## Public Announcement regarding 2017-2022 Ford Super Duty XB LED Tails (LF350 & LF351)

**SKU:** LF350 & LF351

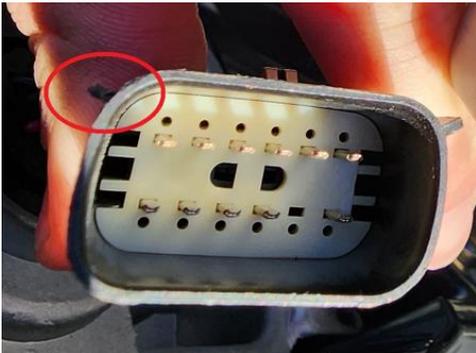
**Issue:** Morimoto taillight harness does not connect to OEM truck connector, specifically trucks with OEM LED tail lights.  
(NOTE: this issue does not effect OEM Incandescent taillight trucks)

**Description:** The connector on Morimoto's 2017-2022 Ford Super Duty XB taillight connector should only include one alignment tab. Some sets were shipped with two alignment tab connectors. Sets with two alignment tabs will not connect to the OEM connector on trucks with OEM LED taillights.

Connectors should look like this:

If your connector looks like this AND you have an OEM LED taillight, then you will need to perform the remedy described below:

**Remedy:** Customer can fix the issue by carefully trimming the tab with a razor blade (away from their body) or similar sharp tool. Please use all proper precautions when working with sharp tools.
